Struthers Ranch Polaris Grading & Erosion Control Plans El Paso County, Colorado

GEC PLAN
TITLE SHEET

Grading & Erosion Control Plan_V2.pdf Markup Summary

HORIZ. SCALE: 1"=30'	DRAWN: PV
VERT. SCALE: N/A	DESIGNED: JPS
SURVEYED: COMPASS	CHECKED: JPS
CREATED: 05/27/20	LAST MODIFIED: 10/21/22
PROJECT NO: 032203	MODIFIED BY: PV
SHEET:	C1.1

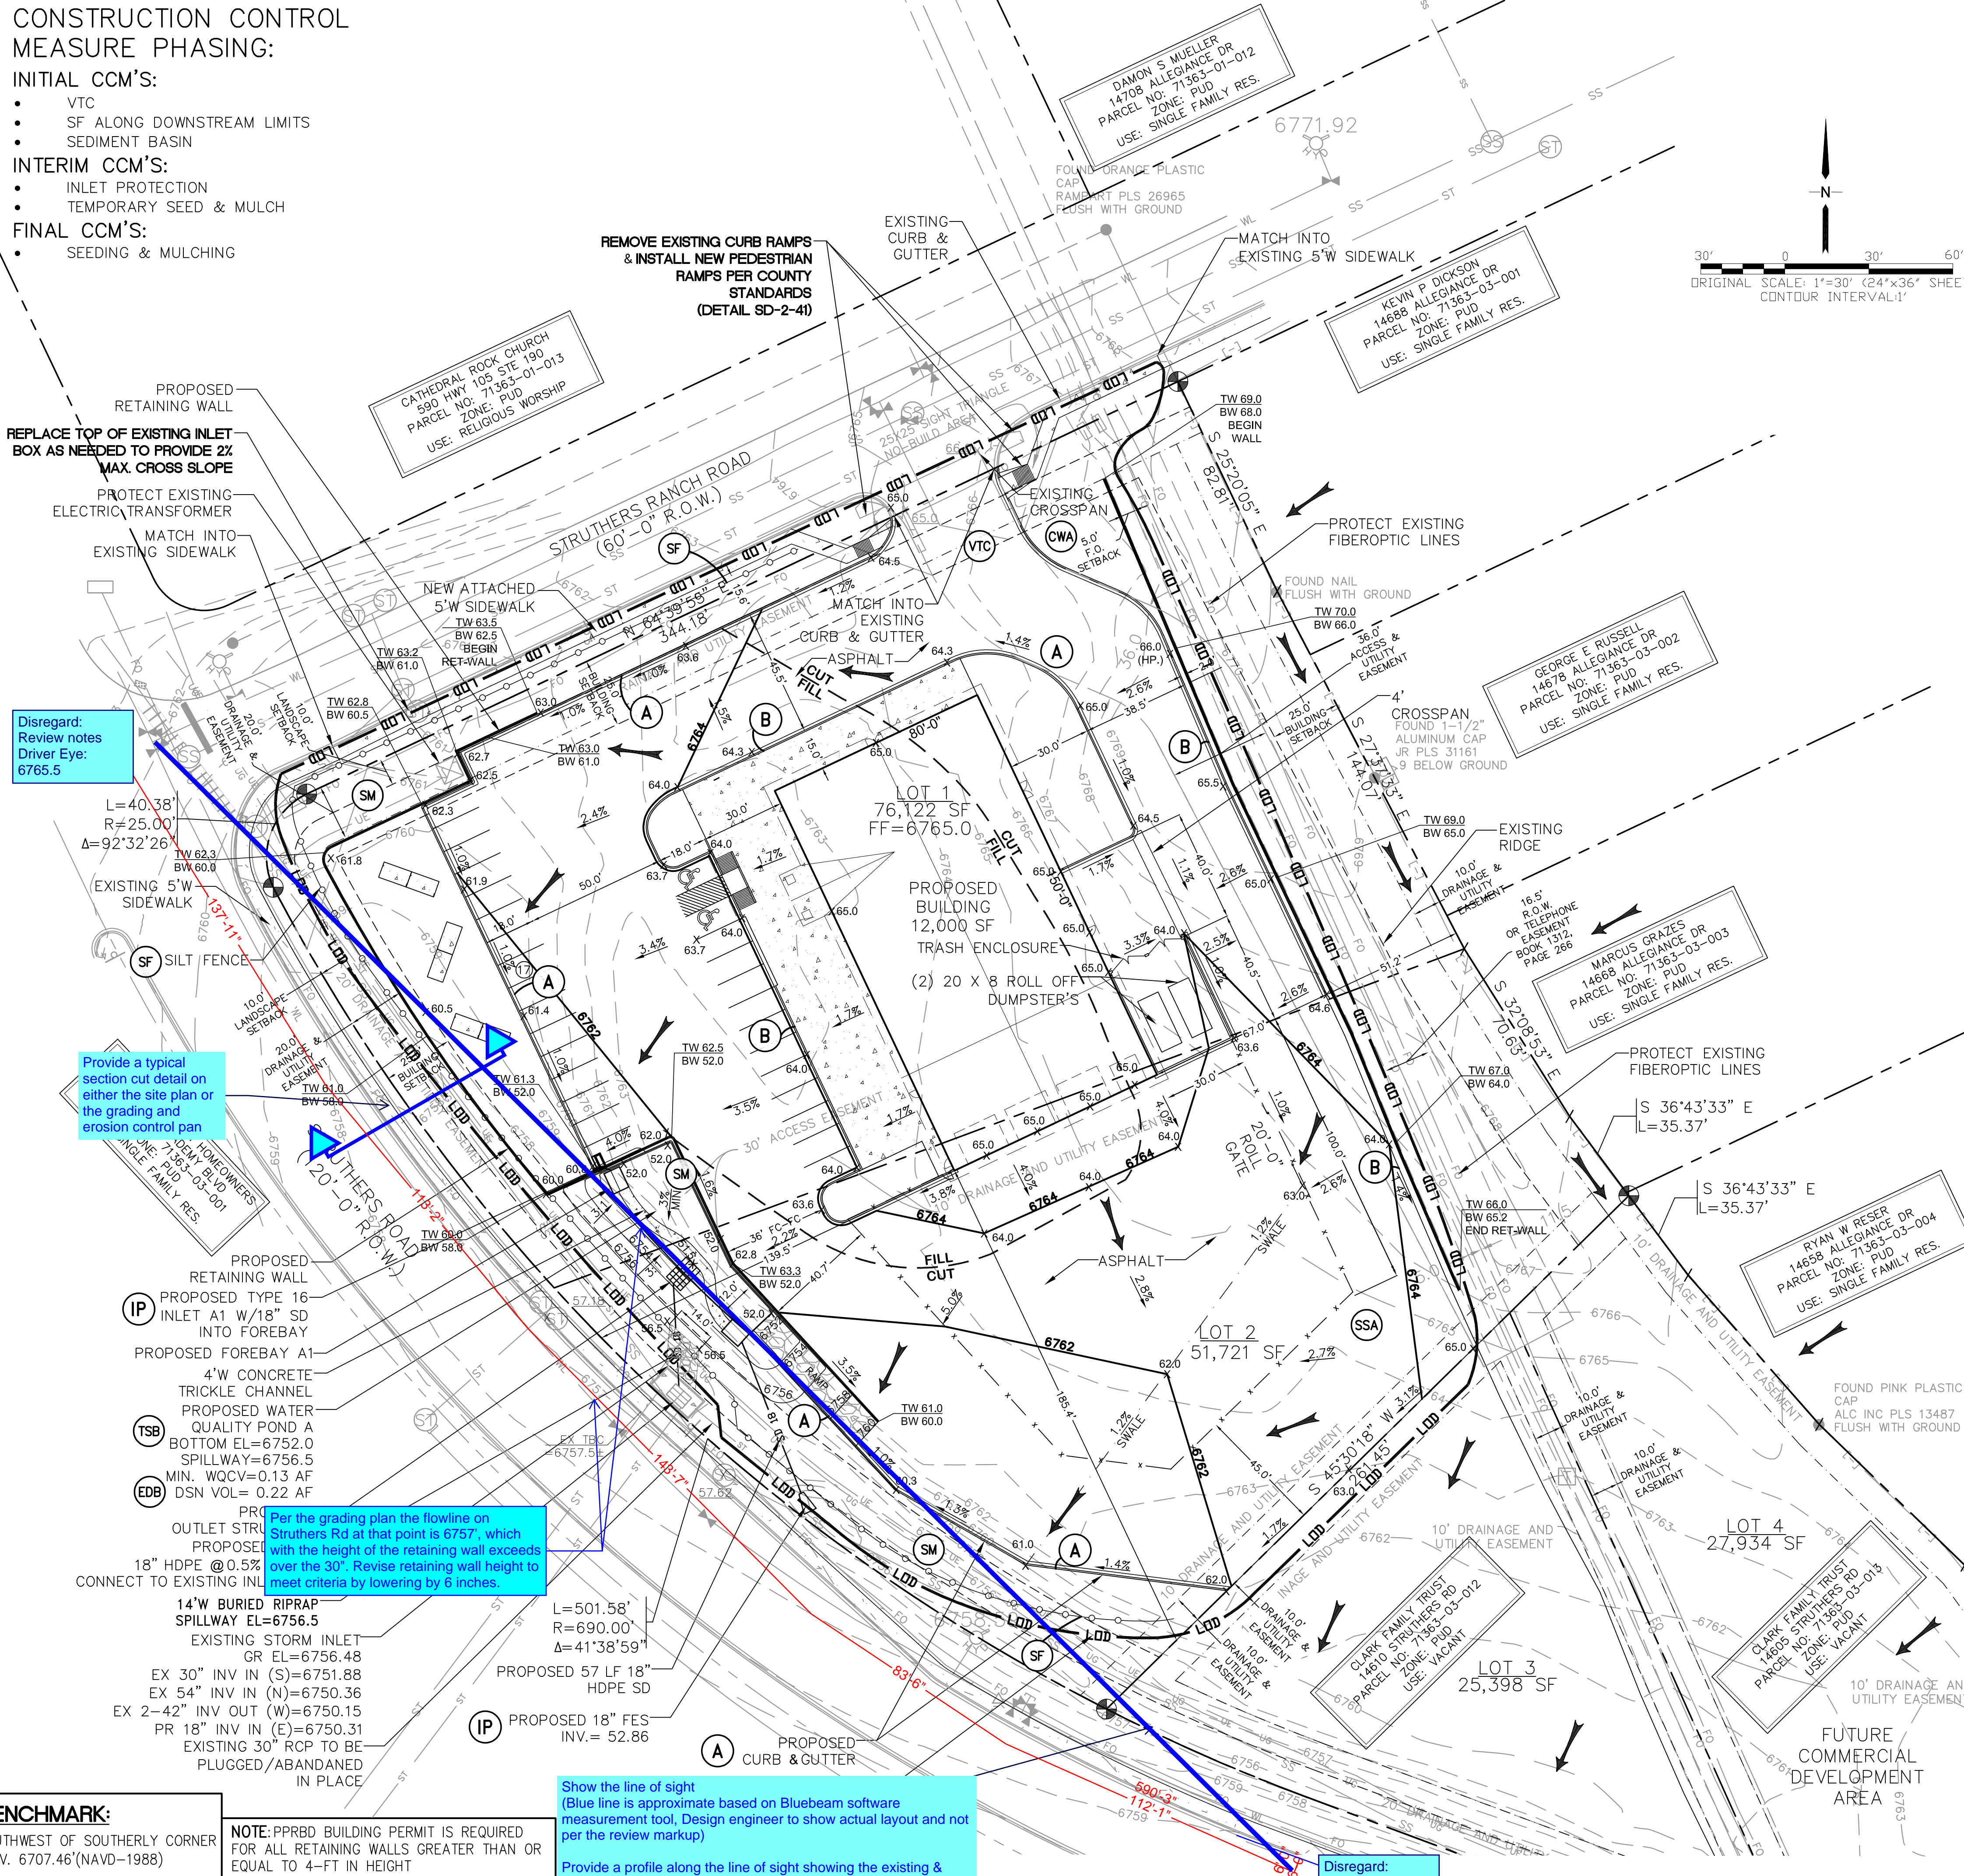
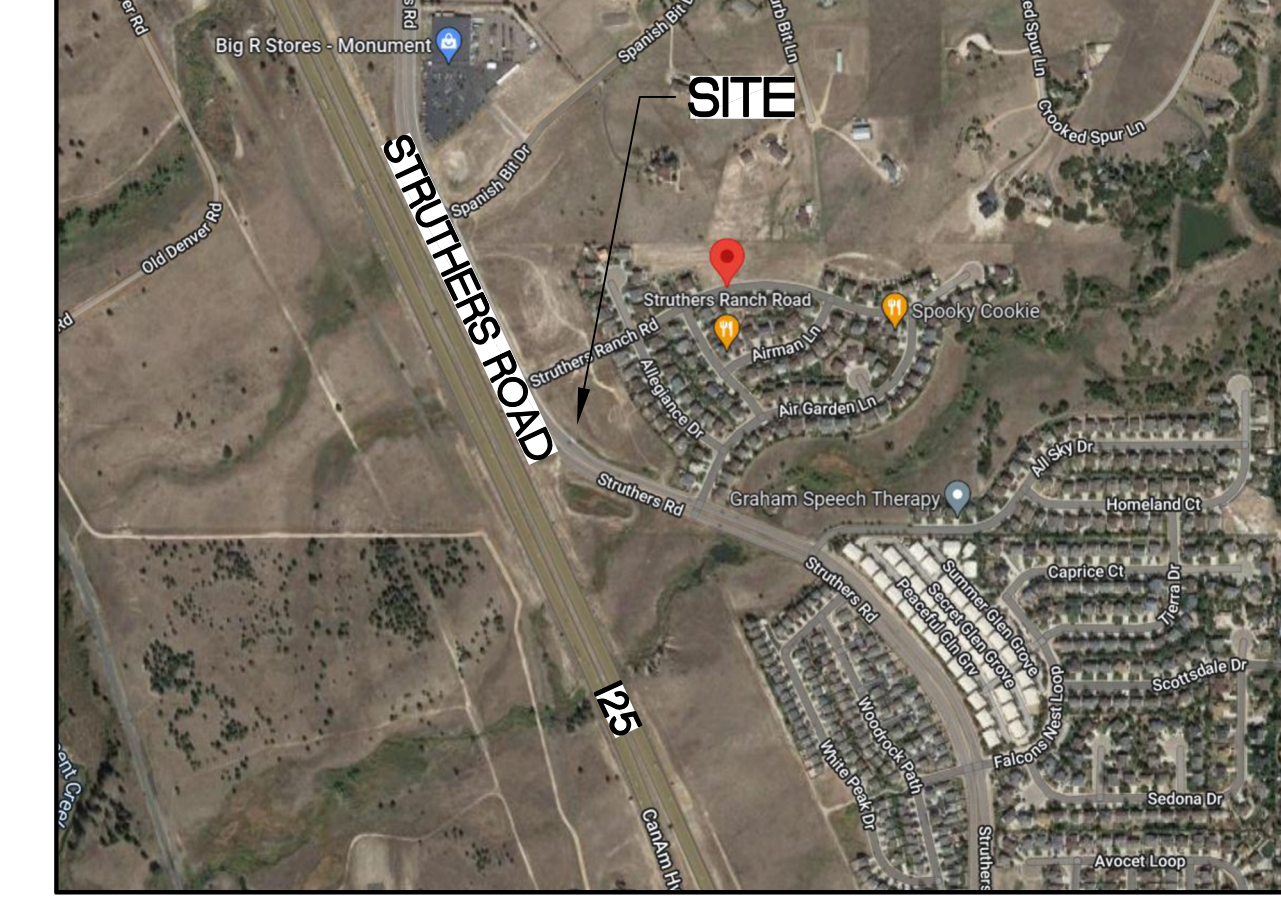
Provide a typical section cut detail on either the site plan or the grading and erosion control plan

Per the grading plan the flowline on Struthers Rd at that point is 6757', which with the height of the retaining wall exceeds over the 30'. Revise retaining wall height to meet criteria by lowering by 6 inches.

Show the line of sight (Blue line is approximate based on Bluebeam software measurement tool. Design engineer to show actual layout and not per the review markup)

Provide a profile along the line of sight showing the existing & proposed ground, and line of sight from driver's eye to object height per criteria.
